Crown Street, Phase 3 – Manchester

DESIGN & ACCESS STATEMENT - ADDENDUM | APRIL 2024
Z1-SHP-A180-RP-XX-B5D803 | REVISION X03

GROUND AND FIRST FLOOR HIGH LEVEL DETAIL

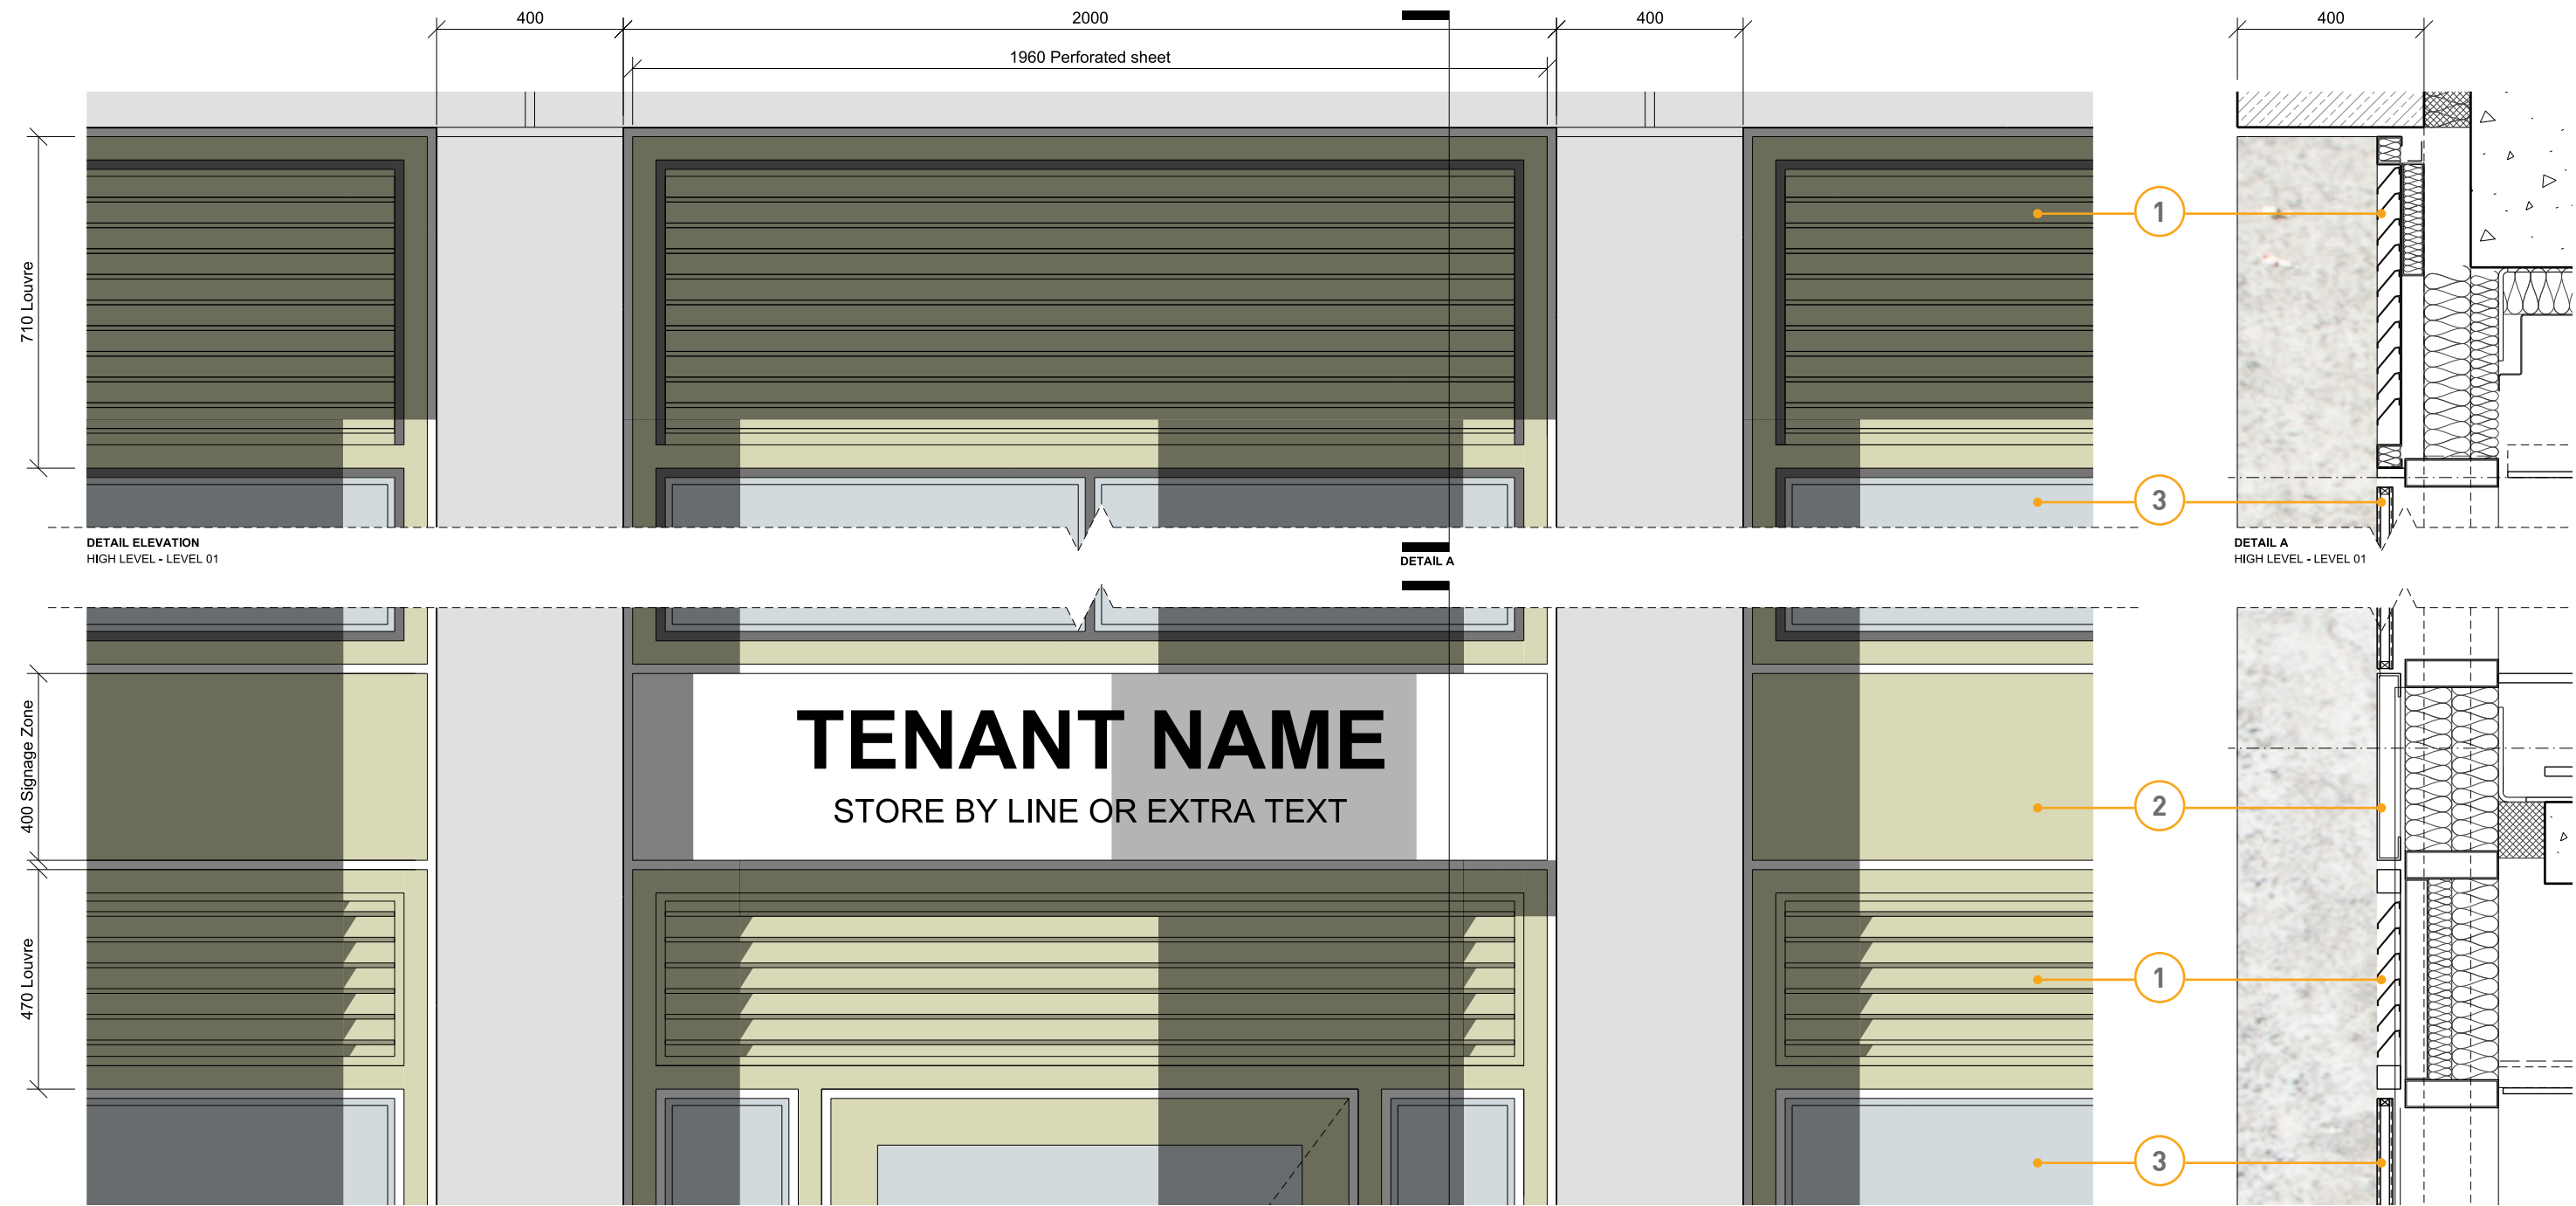
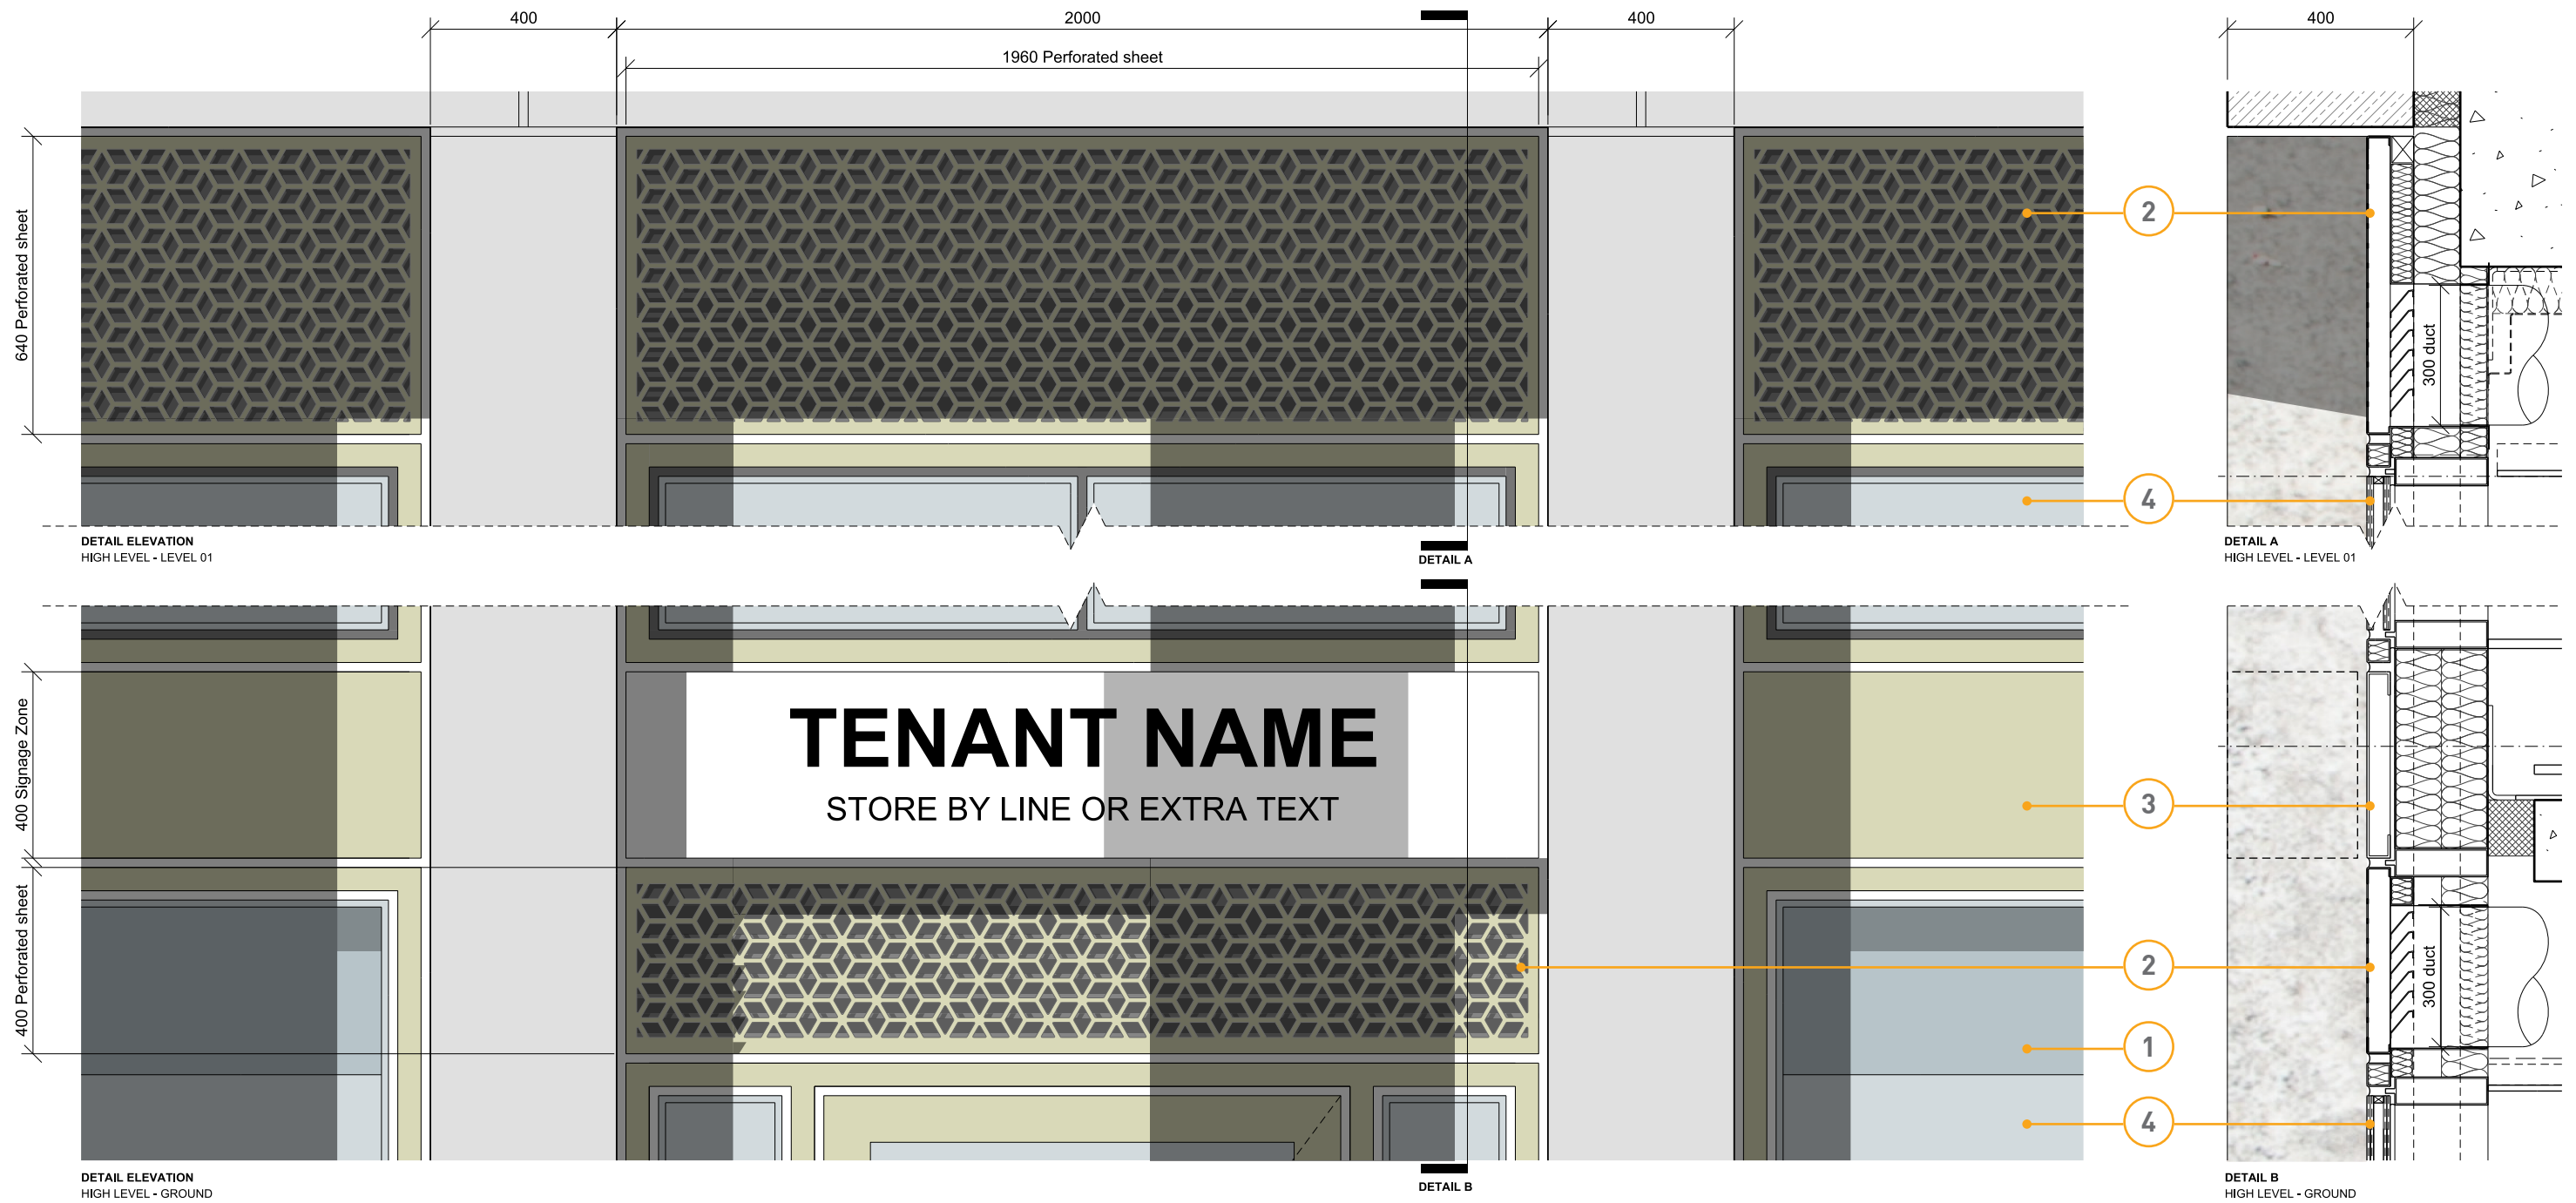
Please would you also look at replacing/screening the louvres around the waste storage and substation/plant areas with more decorative perforated panels (eg to match those used for purge vents on the upper floors of the building).

Continuous high level louvre band at ground and first floor.

In areas where it is not possible to remove the ventilation requirements, high quality perforated anodised aluminium screens have been introduced in front of the louvres. The face of the anodised screen will line through flush with the glazing below with the louvre design adjusted accordingly.

The proposed perforated pattern design itself seeks to acknowledge the distinctive floor plan geometry of the towers above. The panels will be anodised in silver / champagne to match the anodised finishes of the aluminium elements in each of the towers (C7/C8 - Champagne, E1/E2 - Silver).

1. Louvre removed, glazing extended to full height
(bulkhead behind)
2. Anodised perforated sheet in front of louvres
3. Aluminum spandrel (Finish: Champagne)
4. Clear glazing

1. Louvre removed where possible, glazing extended to full height (*bulkhead behind*)
2. Anodised perforated sheet in front of remaining louvres
